**Addendum No. 3**

**Final Environmental Impact Report  
for Metro Gold Line Foothill Extension - Azusa  
to Montclair (SCH 2010121069)**

**Evaluating Minor Design Changes of the Project  
Azusa to Montclair**

Metro Gold Line Foothill Extension Construction Authority  
March 2016

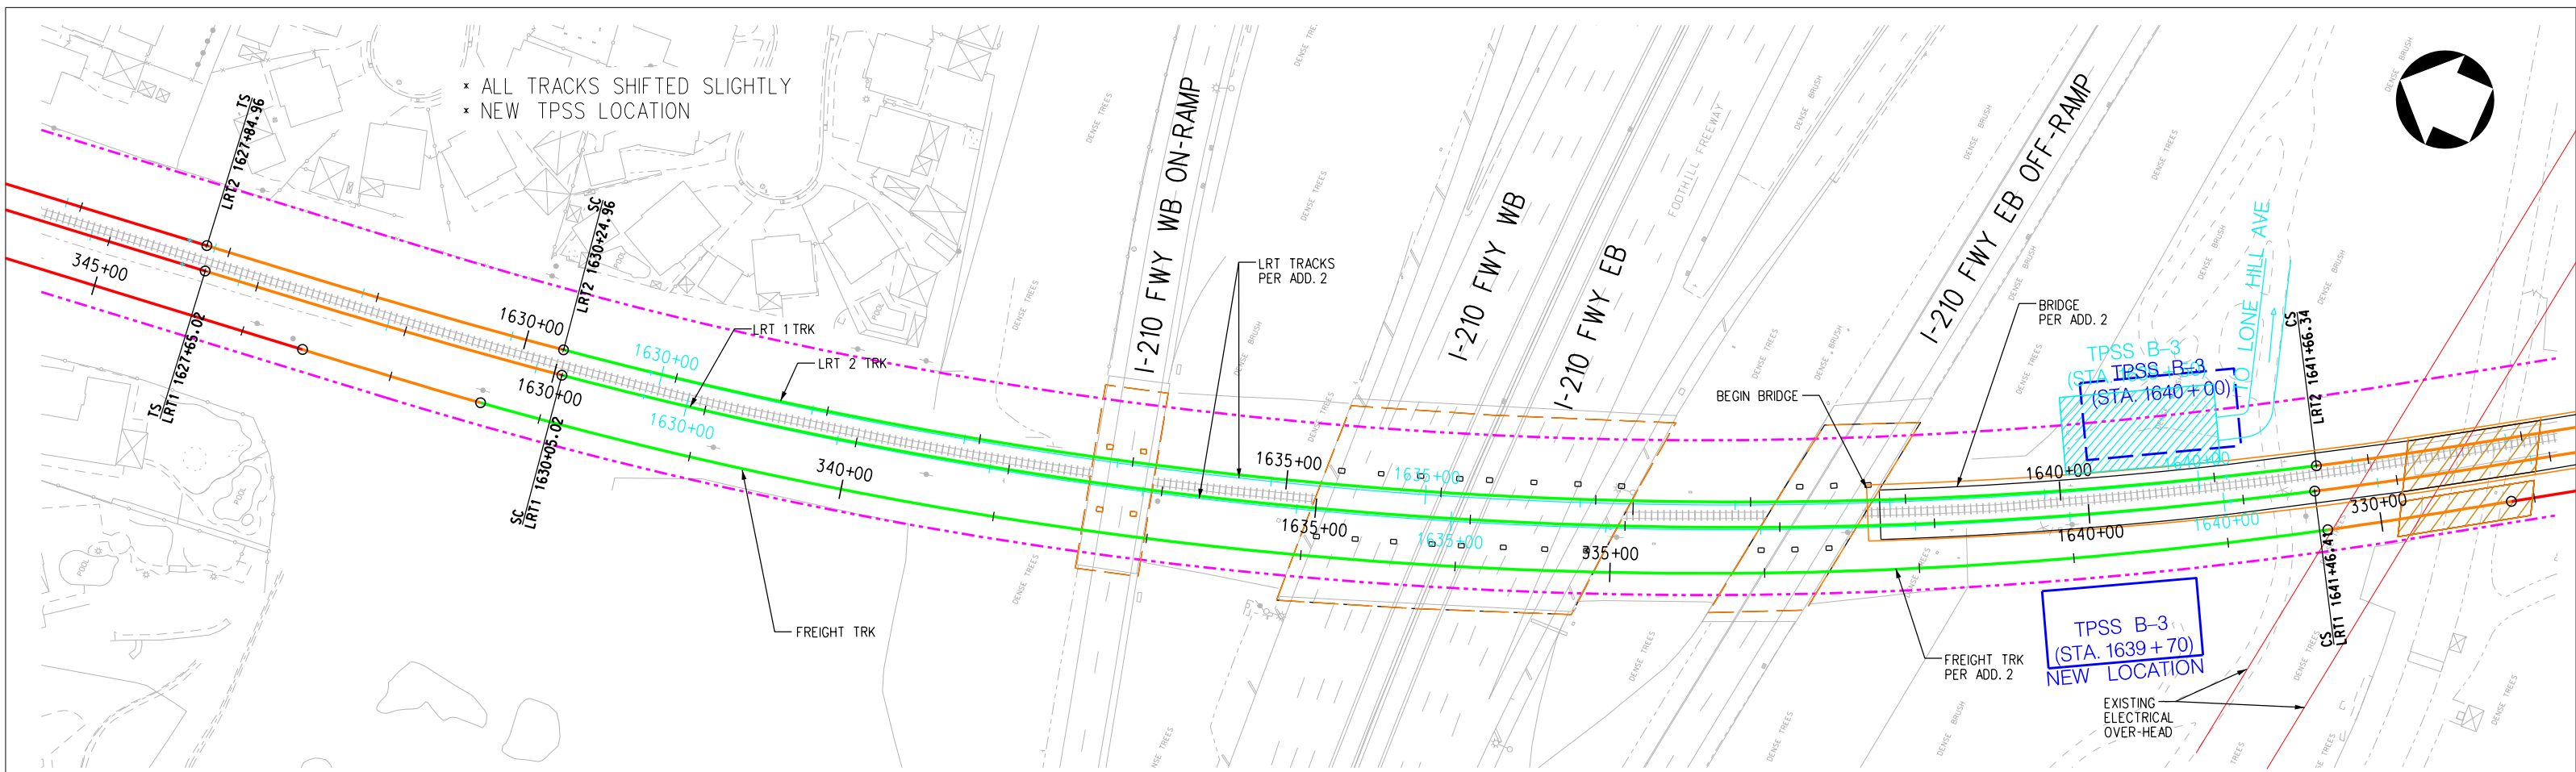
- \* TRACKS LRT1 AND LRT2 SHIFTED NORTH
- \* FREIGHT TRACK SHIFTING NORTH
- \* ADDED 2 NEW #20 CROSSOVERS

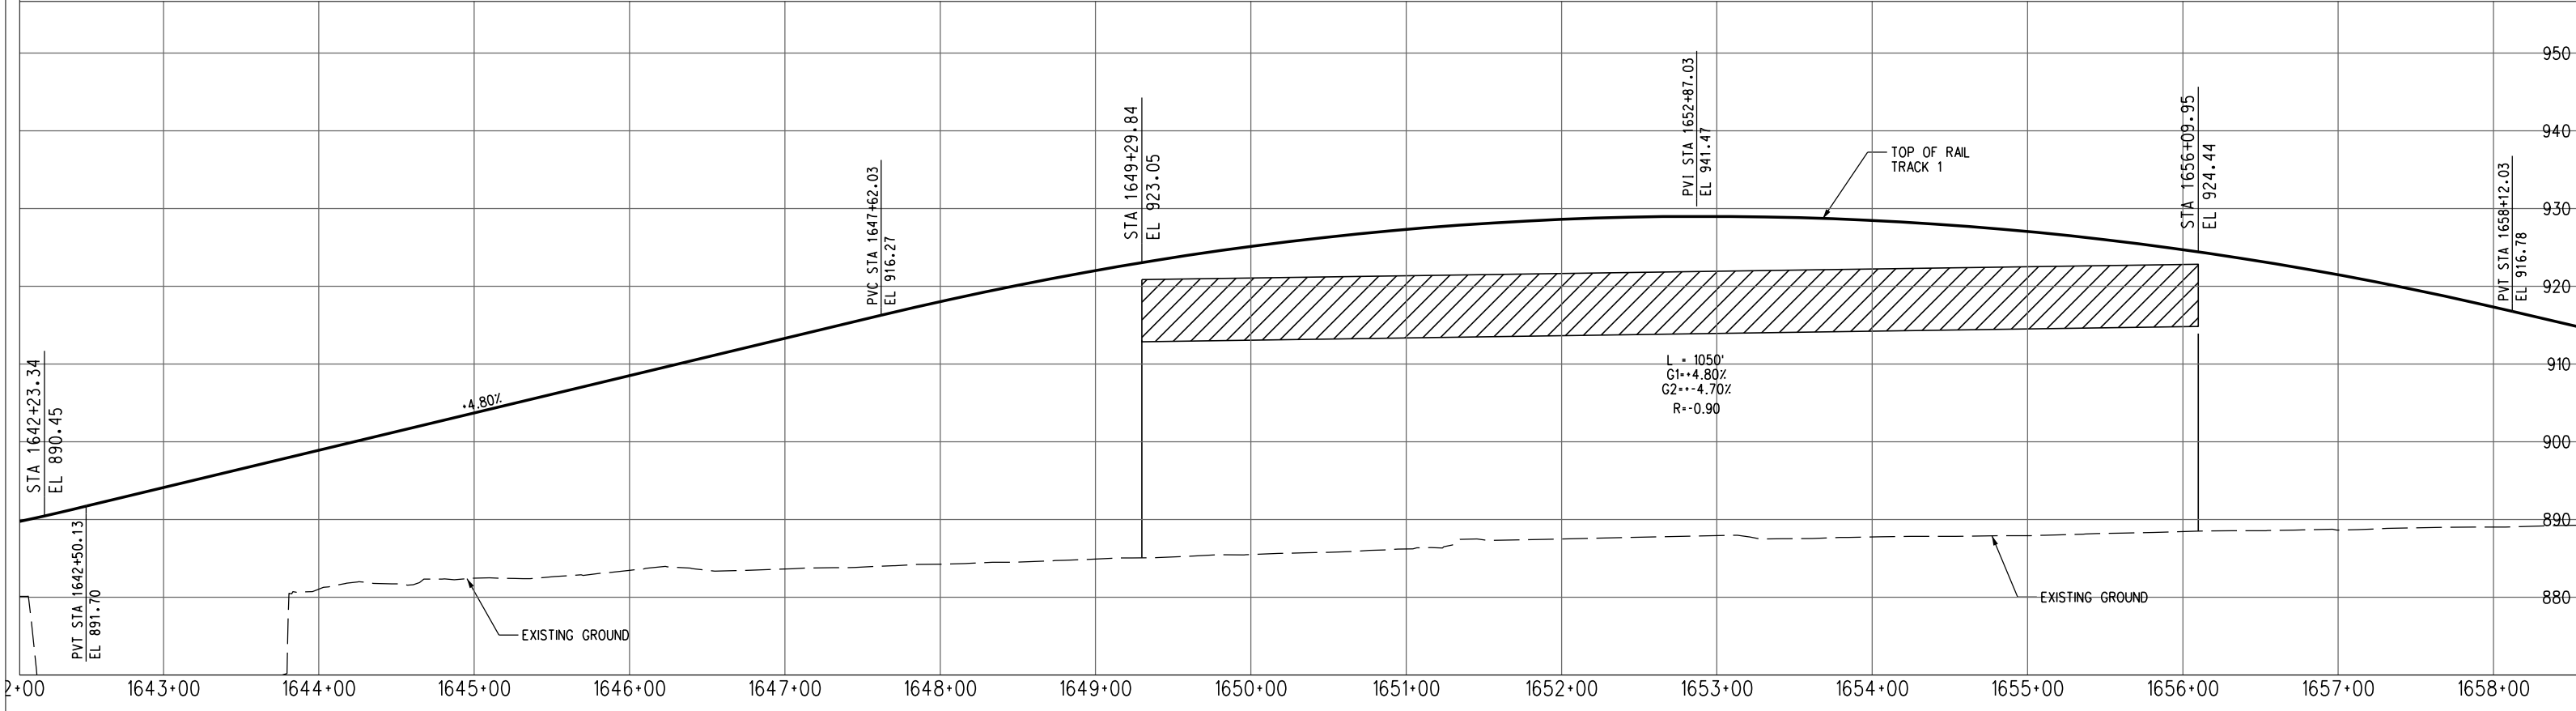
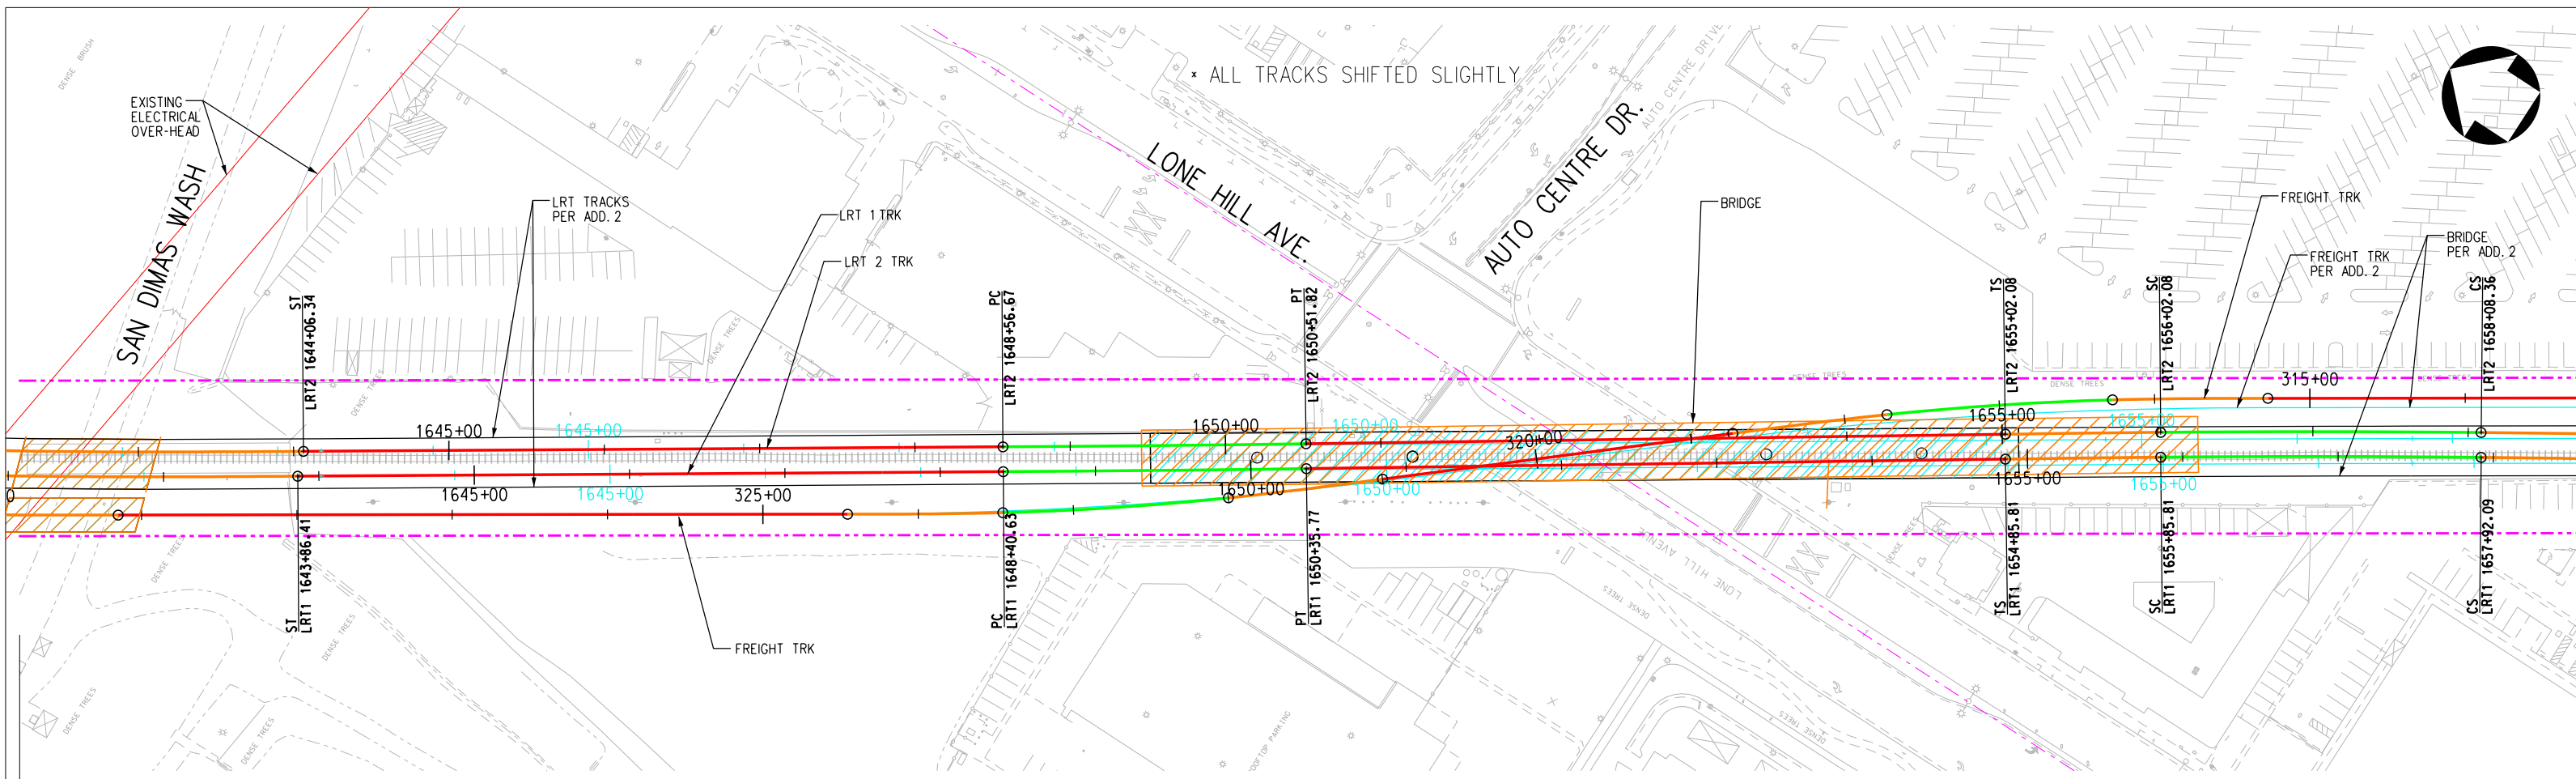
\* ALL TRACKS SHIFTED SLIGHTLY
